SQ Birichina Ltd Unit 2

SQ Station, Jamirdia, Bhaluka, Mymensingh
(24.283 N, 90.392 E)
19 October 2015

Observations

Heavily Loaded Columns (all columns)

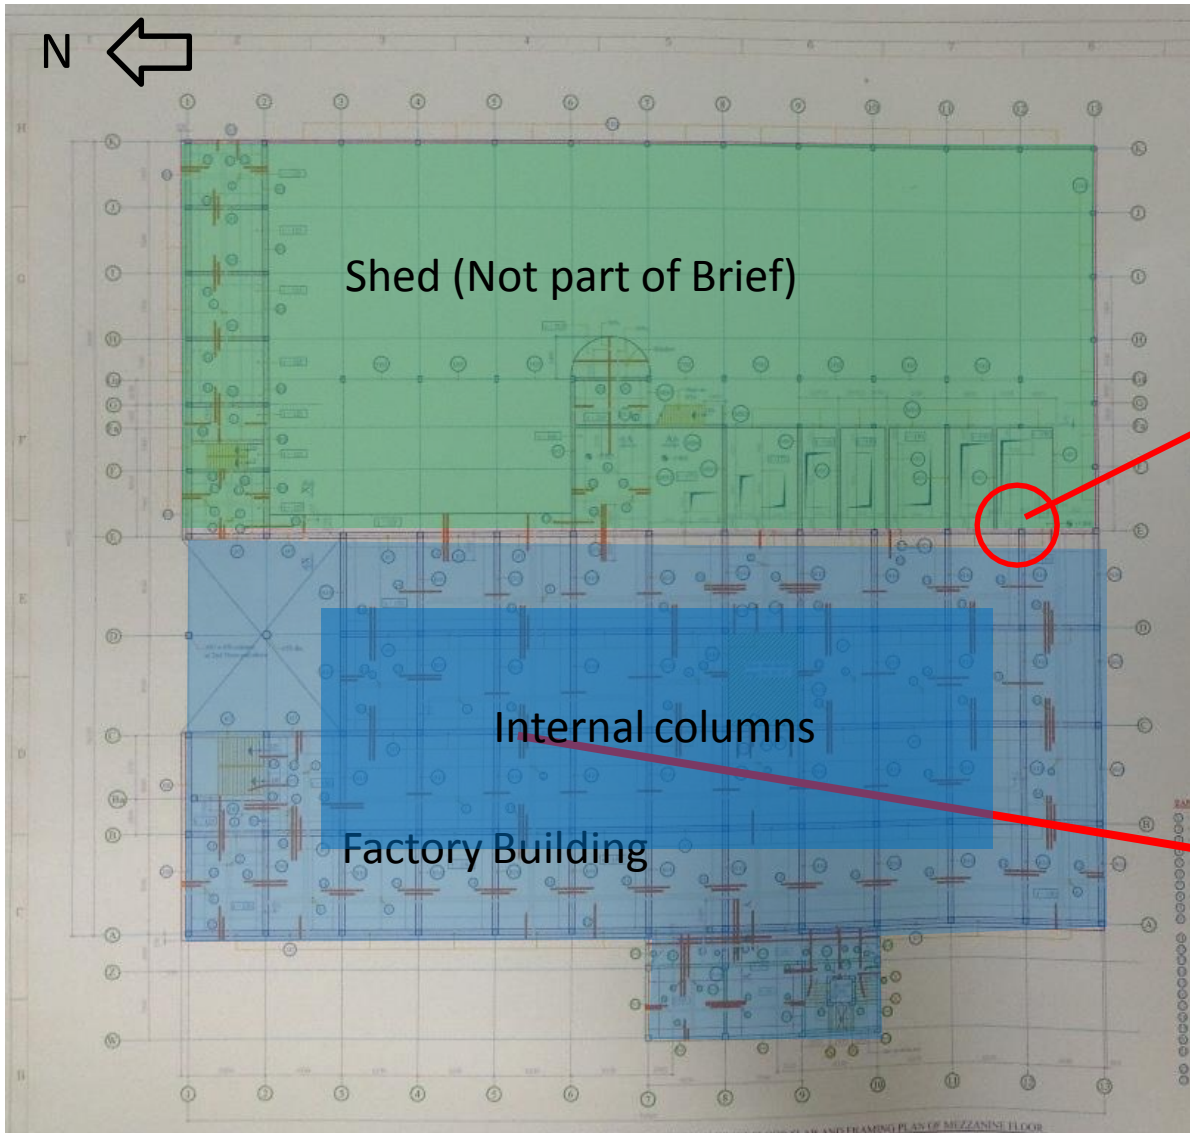
All columns are heavily loaded under current loading conditions at ground and first floors and should be reviewed immediately.

Crane adds loading to some perimeter columns.

Water tank adds additional loads to some columns.

Item No.	Observation	Recommended Action Plan	Recommended Timeline
1	Heavy loaded columns	Maintain current use of the floors and don't change use or increase occupation, either of which could increase loading. Restrict Crane loading to 2 tonne.	Immediate - Now
2	Heavy loaded columns	Factory Engineer to review design, loads and columns stresses in all columns at ground floor and first floor.	Immediate - Now
3	Heavy loaded columns	Verify in situ concrete strength either by taking 100mm diameter cores from a min of 4 columns in the original building or by using existing cylinder strength data. Verify grade of steel reinforcement.	Immediate - Now
4	Heavy loaded columns	A Detail Engineering Assessment of Factory to be commenced, see attached Scope. This should include an assessment of the as built pad foundations.	Immediate - Now
5	Heavy loaded columns	Produce and actively manage a loading plan for all floor plates within the factory giving consideration to floor capacity and column capacity.	6-weeks

Factory Building Plan

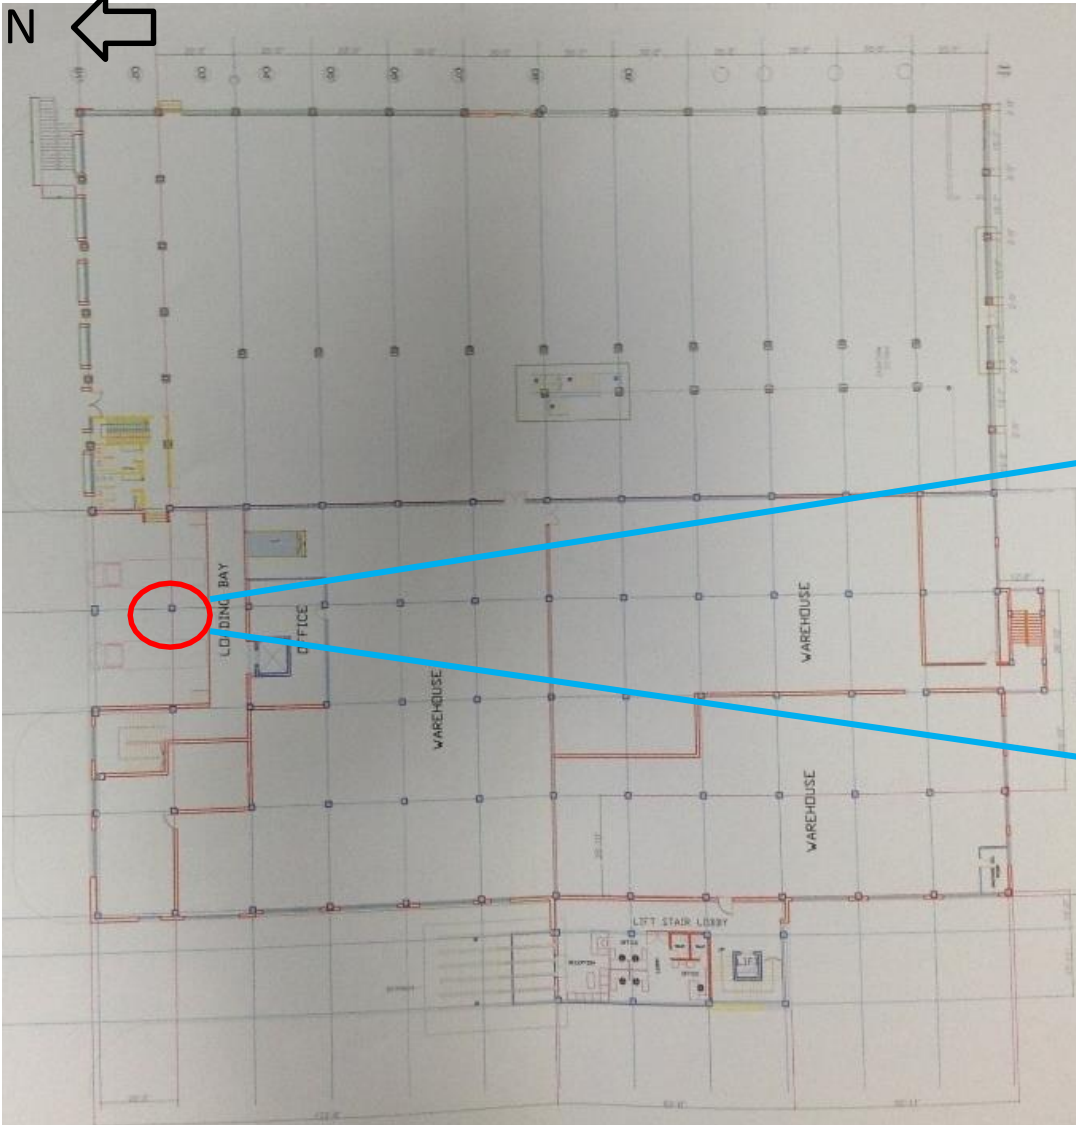
**Composite beams appear to be
under-designed**

Composite beams appear under designed. Flange thickness circa 5mm.

Column in loading bay unprotected from truck impact

Unprotected column in front of loading bay at north . Signs of impact on side of column

Item No.	Observation	Recommended Action Plan	Recommended Timeline
18	Composite beams appear to be under-designed	As part of the DEA the Engineer to verify the capacity of the composite beams at roof level	6-weeks
19	Composite beams appear to be under-designed	Carry out any alterations as required by the DEA	6-months
21	Column in loading bay unprotected from traffic (possible signs of previous collisions)	Design column protection to prevent traffic impact	6-weeks
22	Column in loading bay unprotected from traffic (possible signs of previous collisions)	Install column protection	6-months
24	Water Tank on roof	As part of the DEA the composite deck to be checked for loading from tank/machinery room	6-weeks
25	Water Tank on roof	Carry out alteration as per recommendations from DEA	6-months
